## MEMORANDUM

**Subject:** Second Series of Meetings: Stakeholder/Technical Advisory Group/Far North Bicentennial Park User Group Meeting Notes

INITIAL TRAIL CROSSING CONCEPTS FROM OCTOBER 16,17 MEETINGS  
**EARTHEN OVERPASS CONCEPT**

INITIAL TRAIL CROSSING CONCEPTS FROM OCTOBER 16,17 MEETINGS  
**BRIDGED ROADWAY CONCEPT**

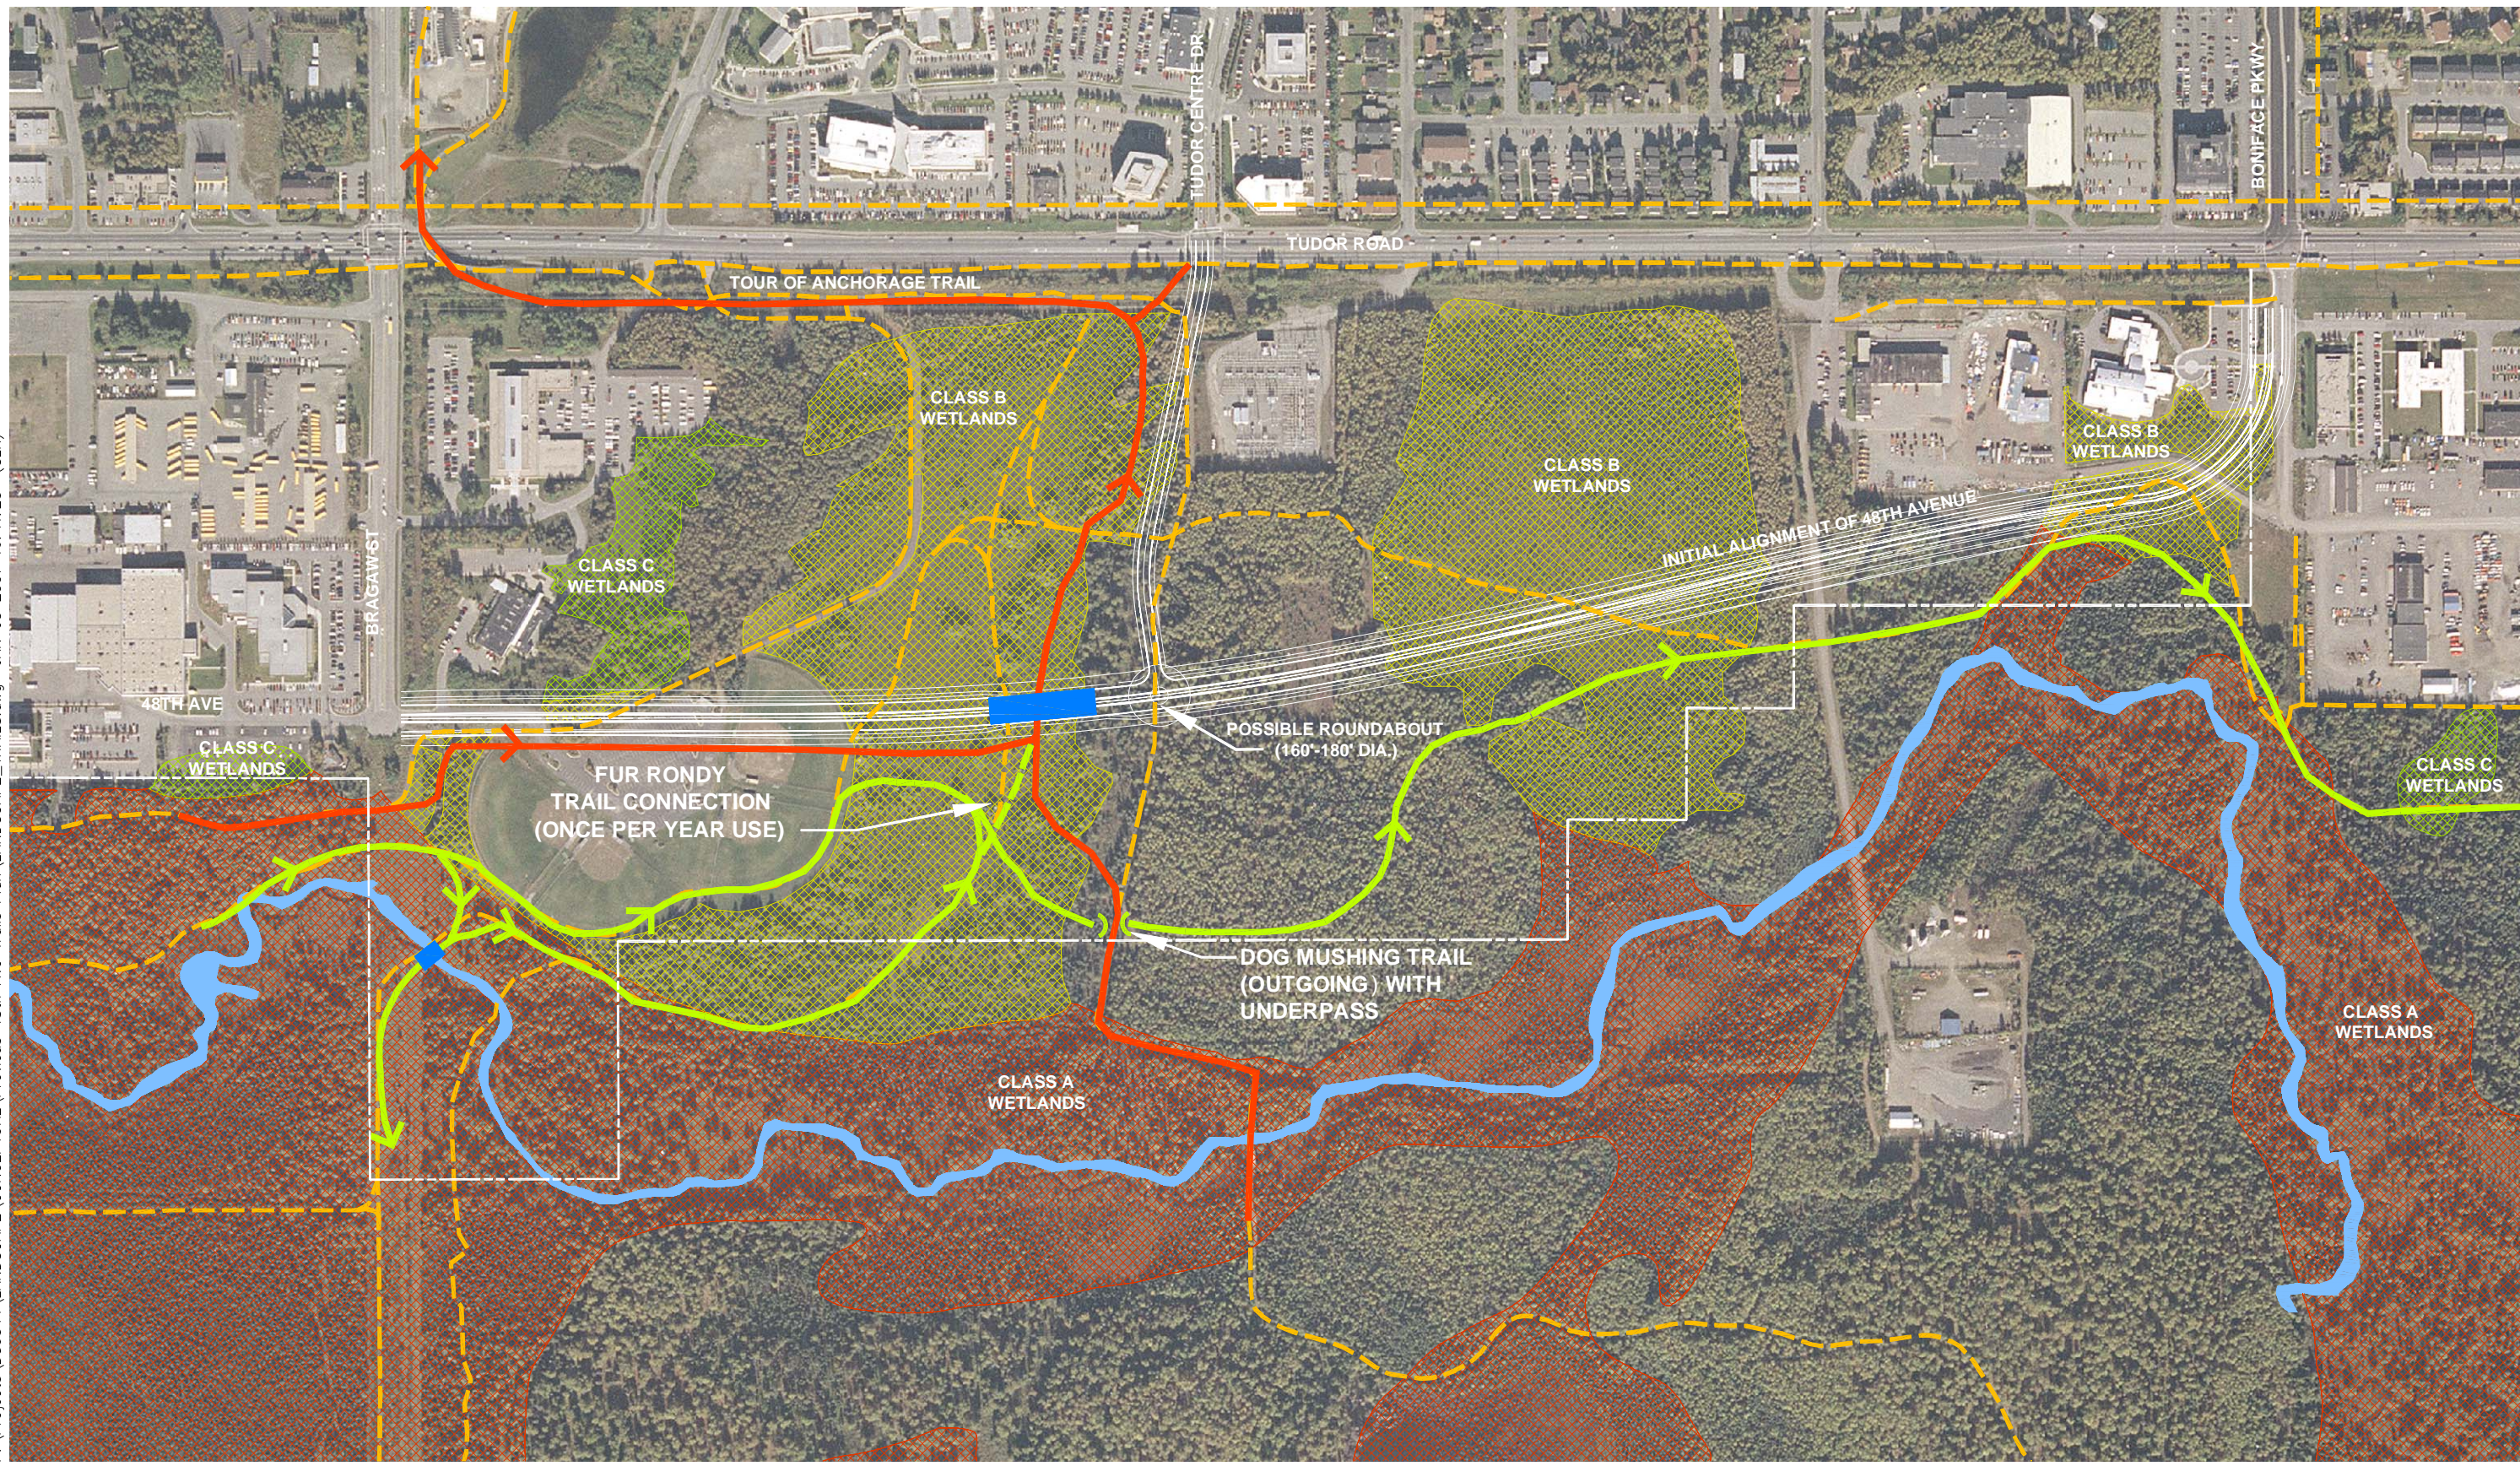
- Bridges over all wetlands.
- Take ball fields down (sized).
- Noise travels further with road elevated. Visual impact more from elevated road.
- Concept 3 separates trails well-snow throw must be controlled.

- Skiers, pedestrians, and bikers prefer an overhead (bridge) crossing; however, this can be made to work. Trail maintenance is not funded like road maintenance. If adequate funds are available, the problems of maintaining snow under a bridge can be solved. Now, the users maintain trails in winter, so problems are significant from our perspective but minor if put in the context of road maintenance.

- High cost of long road trestle is likely to make this option less feasible than the others. Or if it is feasible, it will likely reduce the amount spent on trails.

- Mushing trail needs to be permitted and elevated in Class A off Boniface curve.
- If this option is selected, put lights and snowmaking equipment (possibly portable to use on other tunnels) for underpass of winter trails.
